1/219 BROOME ST

David SHARP + Iris BARTEN

PREVIOUS REPORT FROM COUNCIL MINUTES - 16 DECEMBER 2013

1.2.1 NO. 219 (LOT 34) BROOME STREET - ALTERATIONS AND ADDITIONS TO THREE UNITS

OVERLOOKING STRATEGY TO WEST

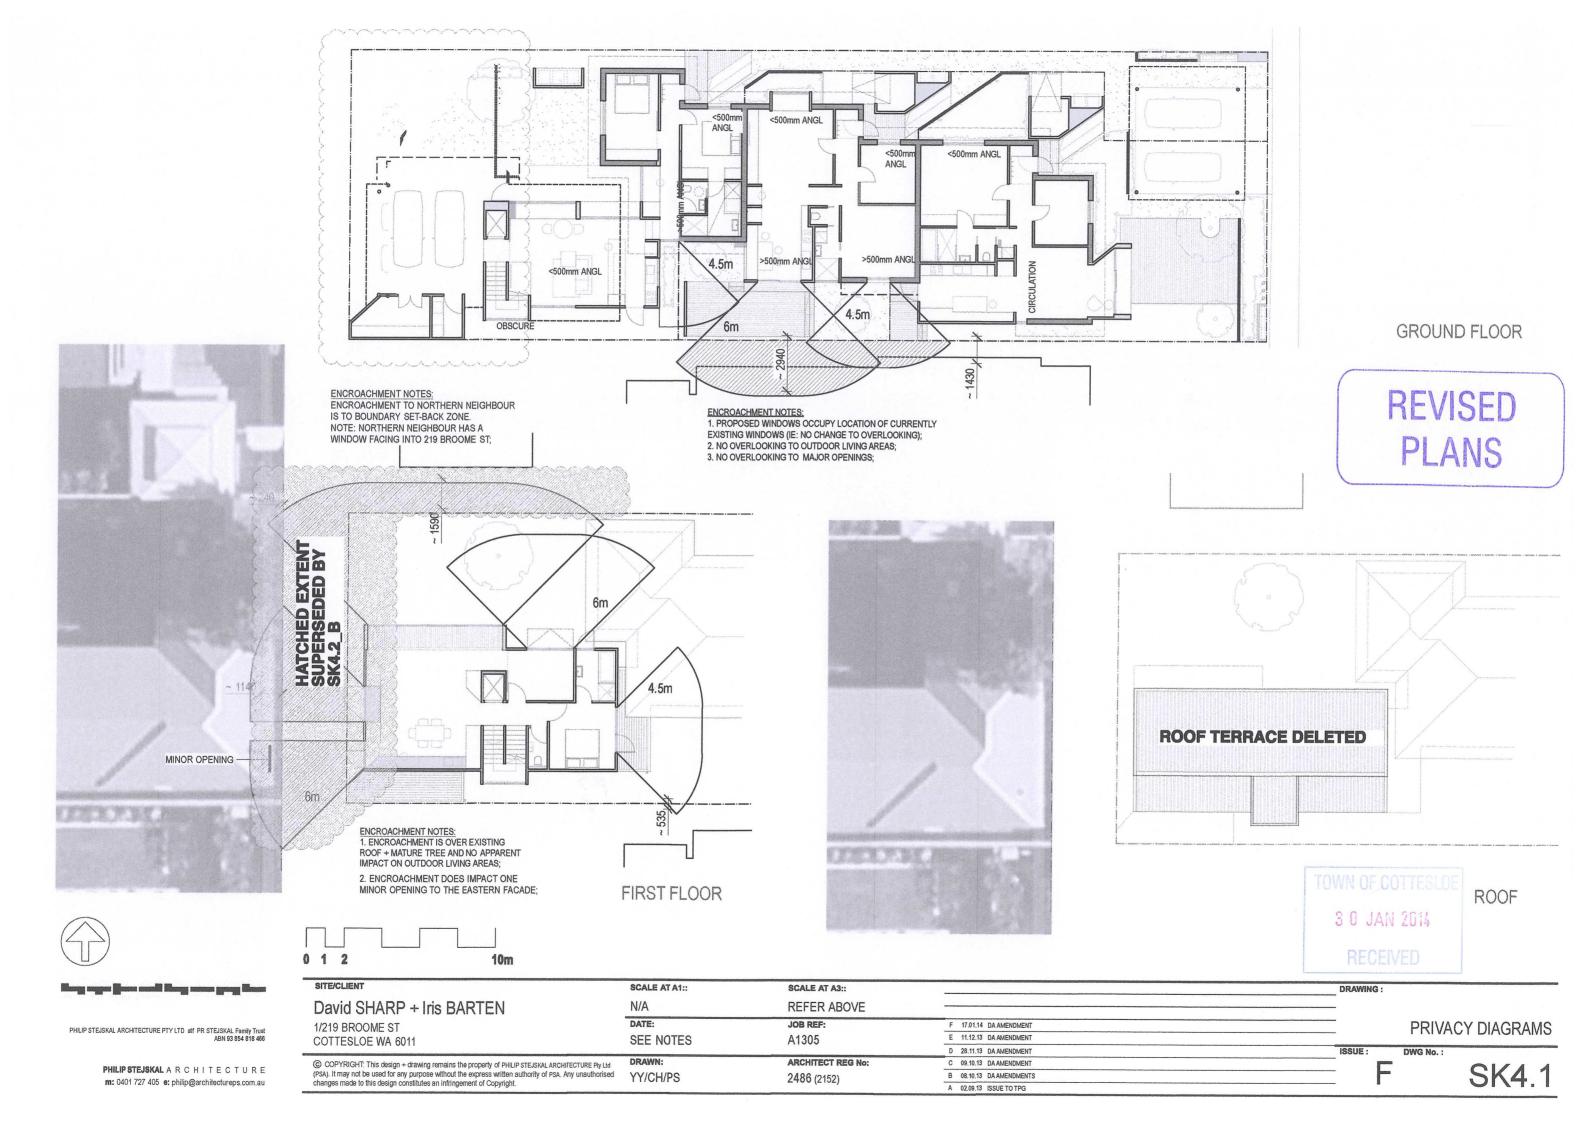
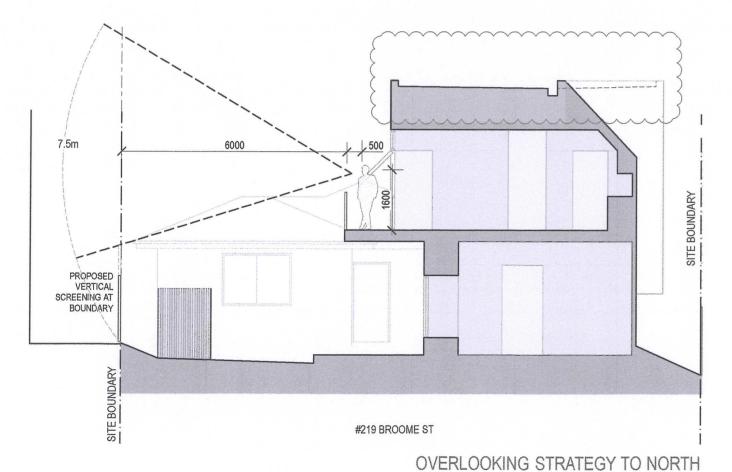
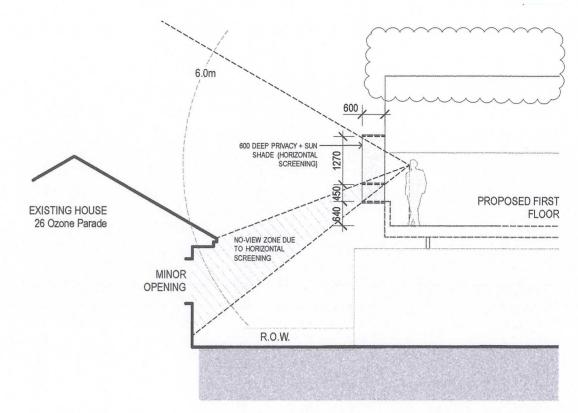
The introduction of a rear second storey and roof terrace give rise to privacy considerations. The setbacks to windows, the balcony and roof terrace are less than the RDC deemed-to comply-standards, whereby the cones of vision affect adjacent properties and this is of concern to neighbours.

The western window overlooks mainly the rear lane and the cone of vision falls to the roof or the dwelling opposite, which has an obscure-glazed window. The applicant has

The roof terrace is setback 7.25m from the northern boundary, just shy of the 7.5m deemed-to-comply standard. This could be accepted as a minor variation or conditioned for a minor design change to comply. To the east the roof terrace overlooks the subject property falling mainly to the roof-scape, which is of little consequence. To the south the roof terrace overlooks the neighbouring back yard but more as a "view over" due to the line of sight being setback, yet the sense of privacy being affected may prevail. To west the outlook is upon the lane and roof of the dwelling opposite, again for a somewhat "distant" view which may also create a sense of privacy intrusion.

Deletion of the roof terrace altogether would obviously remove this privacy situation. Alternatively, the design could be modified to limit the size of the roof terrace, increasing its setbacks or adding screening devices. For example, extending the horizontal plane of the southern edge of the roof terrace would deflect the overlooking above the adjacent property. To the west a greater setback, such as in the form of a fixed/built-in planter box would achieve a similar positive outcome. A condition is recommended accordingly.

- b. the roof terrace shall be redesigned to: achieve a 7.5m setback from the northern boundary; substantially reduce overlooking towards the southern property (such as by an increased setback or increased horizontal screening; and substantially reduce overlooking towards the western property across the lane (such as by an increased setback, horizontal screening or an in-built/fixed planter box); and

OVERSHADOWING

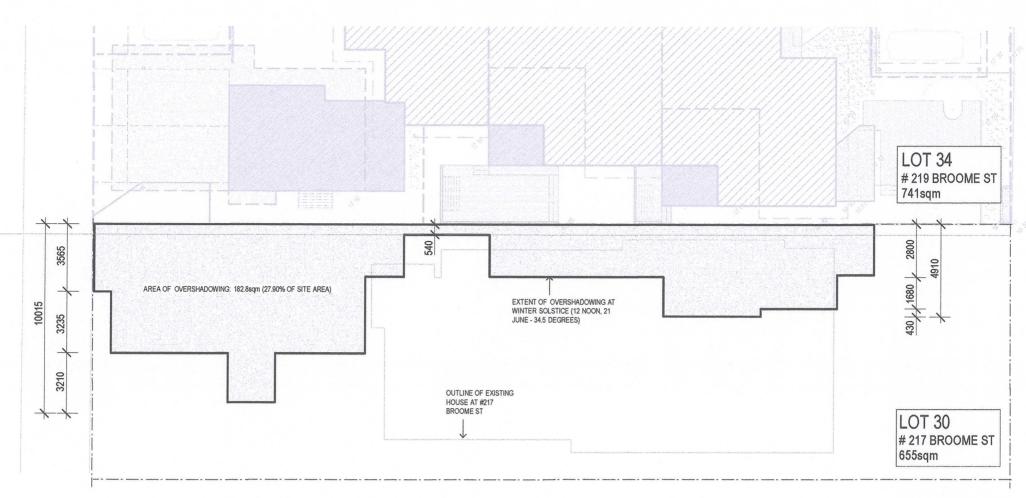
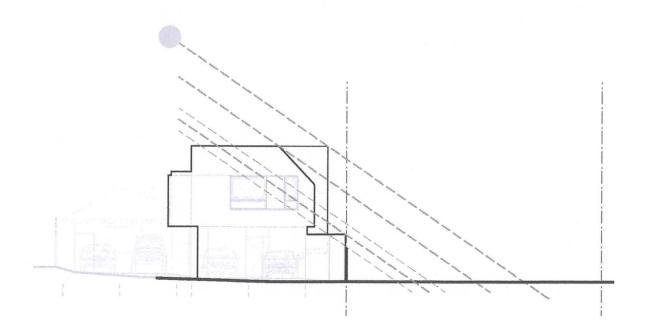
25% overshadow.	28% overshadow.	P2.1 Effective solar access for the proposed development and protection of solar access.
TPS2 Policy 3 front carports.	6m	1.2m	Clause 4 (b).

- Strongly objects to any overshadow concession from the proposed addition to the rear unit. The development should comply with the 25% overshadow allowance.

• Is not considered to have an adverse impact on the adjoining property. The adjoining property to the south has large trees on the boundary which already cast a shadow over the back yard of No. 217 Broome Street.
